# E8362BH85-01

# S E R V I C E N O T E

## E8362BH85 PNA Series RF Network Analyzers

Figure 1

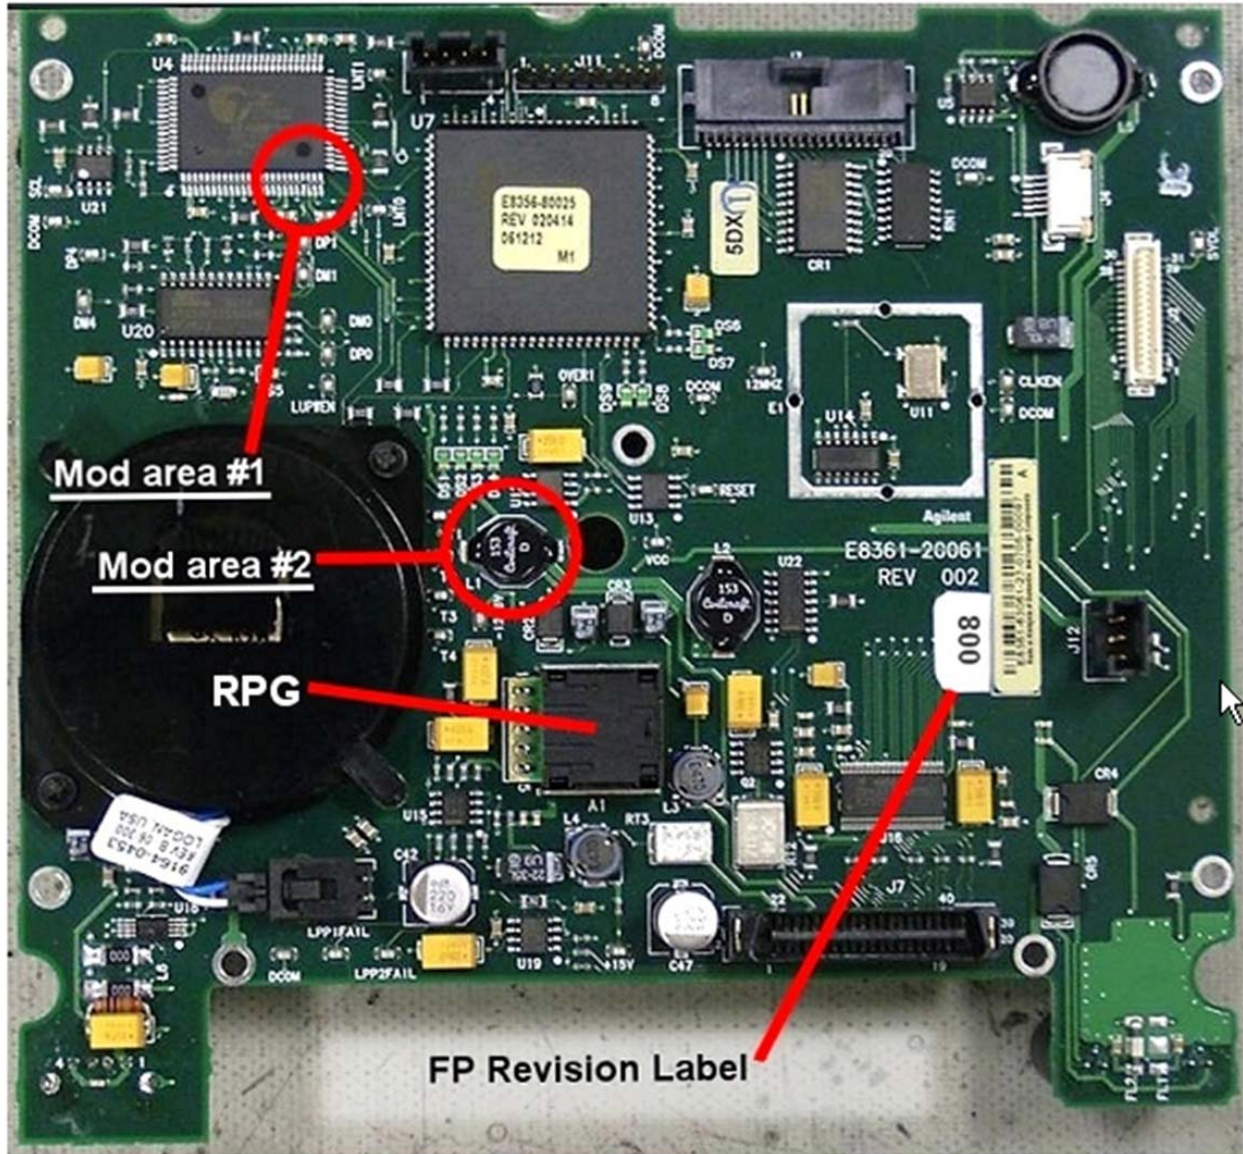
Refer to Figure 1 for the two modification areas to be addressed. Note that while this picture happens to show the FPI board completely removed from the front frame assembly, this is not necessary to perform the required modifications.

- Modification #1 consists of shorting two pins of U4 together with a small amount of solder.
- Modification #2 consist of removing L1.

**Figure 2**

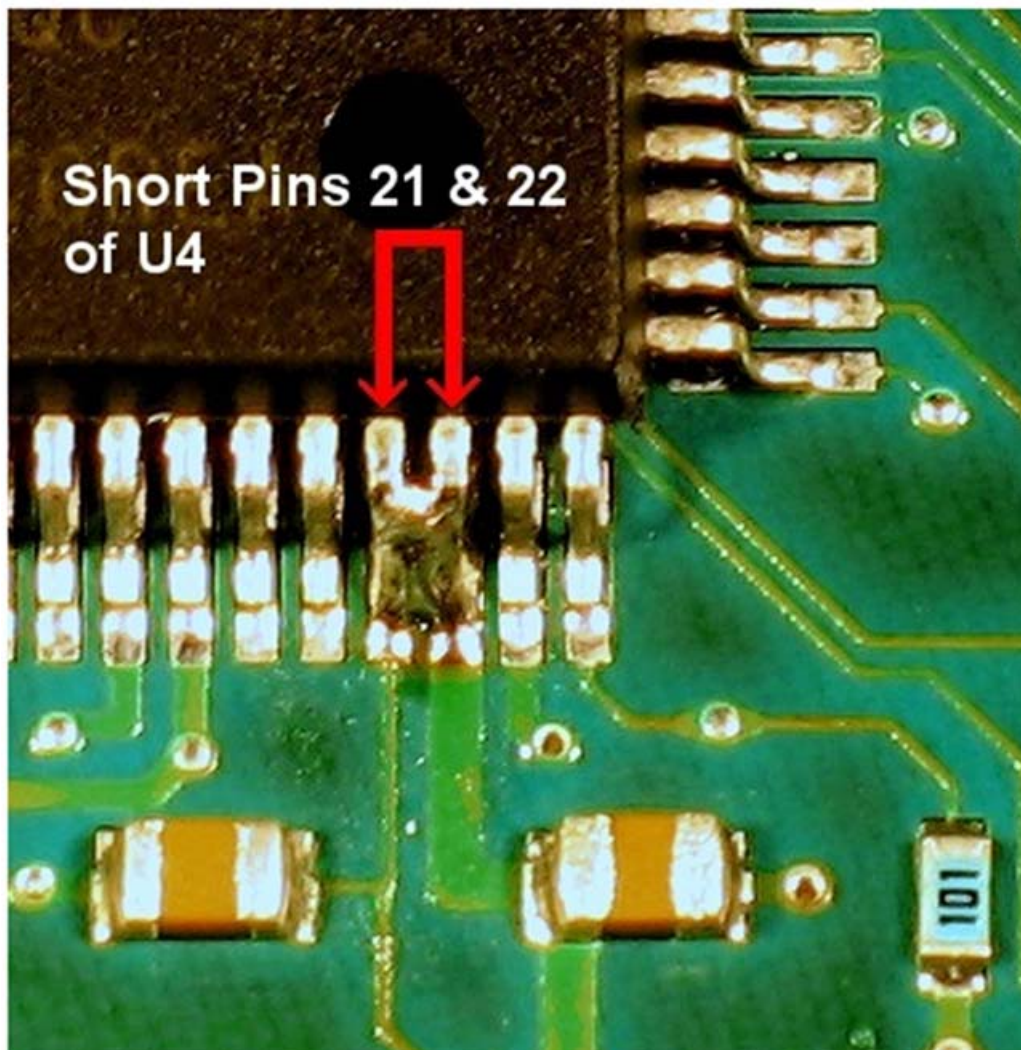
Carefully solder pins 21 and 22 together on U4. Refer to Figure 2 for the exact location. Use care so that no other pins are shorted. Use of a very fine tip soldering iron is recommended and a large work-task magnifying glass is very helpful.

Unsolder and completely remove the black surface mount inductor L1 from the front panel assembly board. This is no longer needed and can be discarded.
